Doc. Type: Disposition of comments

Title: Disposition of comments on SC2 N 4239 (PDAM2.2 text to ISO/IEC 10646 3rd edition)

Source: Michel Suignard (project editor)

Date: 2012-10-24

T7. Page 114, Row 1F68: Transport and Map Symbols.

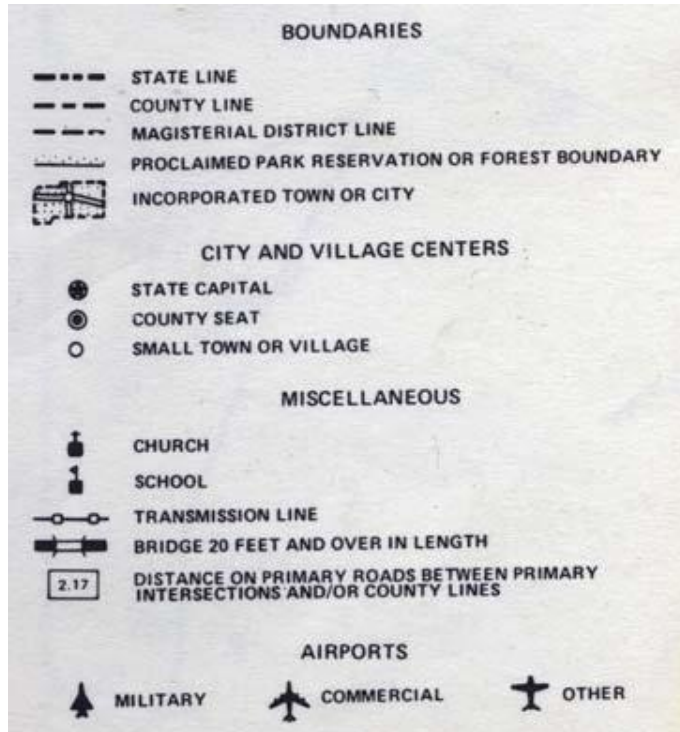
Ireland requests two character additions, along with additional annotations to one character already on the ballot.

1F6E6 MILITARY AIRPLANE

- military airport

1F6E7 UP-POINTING AIRPLANE

- commercial airport

1F6E8 SMALL AIRPLANE

- airfield

The postscript name for 1F6E8 SMALL AIRPLANE is “planesmall”, indicating a kind of small aircraft. the Webdings glyph shown in perspective is hard to identify and too “pictorial”. Further, we have found evidence for the SMALL AIRPLANE character used not only as a Webdings dingbat, but as a Transport and Map symbol used alongside MILITARY AIRPLANE and UP-POINTING AIRPLANE to indicate different kinds of airports.

At the bottom of the legend here three airports, “military”, “commercial” and “other” are indicated with three types of aircraft. The map from which this legend comes is a map of Northampton County published in 1989 by the Virginia Department of Transportation in cooperation with the U.S. Department of Transportation’s Federal Highway Administration.

Accepted in principle

Again, concerning the proposed character 1F6E7 (code point in ballot) SMALL AIRPLANE, one should not read too much in the postscript names of Wingdings and Webdings. These names were not publicly available and most users have put these characters in documents expecting the glyphs to stay close to their original design. The expectation when encoding the Webdings and Wingdings characters is to only replace their glyph if the substitution is acceptable when the only change to a document is re-encoding from the original private use area to a regular area. For example, many recent glyph changes have consisted in going from black figures to outlines and resizing.

In that aspect the proposed glyph change for the small airplane is too radical. It is preferable to keep the small plane as it is (or at least with minimum changes) and to add another character to complete the requested set to represent the full set shown above.

This results in three additions:

1F6E6 UP-POINTING MILITARY AIRPLANE

1F6E7 UP-POINTING AIRPLANE

1F6E8 UP-POINTING SMALL AIRPLANE

In addition the previously proposed SMALL AIRPLANE is moved to 1F6E9.

TE.8. Changes in glyphs from black to white in Pdam2.2

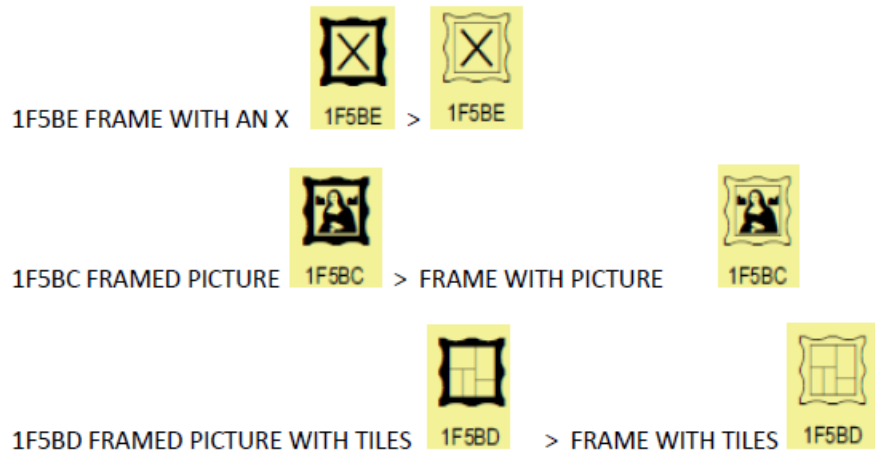
In several cases the change from "black" to "white" makes the symbol less recognizable and the change does not seem to be motivated. We suggest that the original glyph be restored (/revised, if applicable – see comments below).

a) FRAMED PICTURE characters

Based on the General comment above, we recommend all picture frame glyphs be reverted to the earlier glyphs.

Accepted
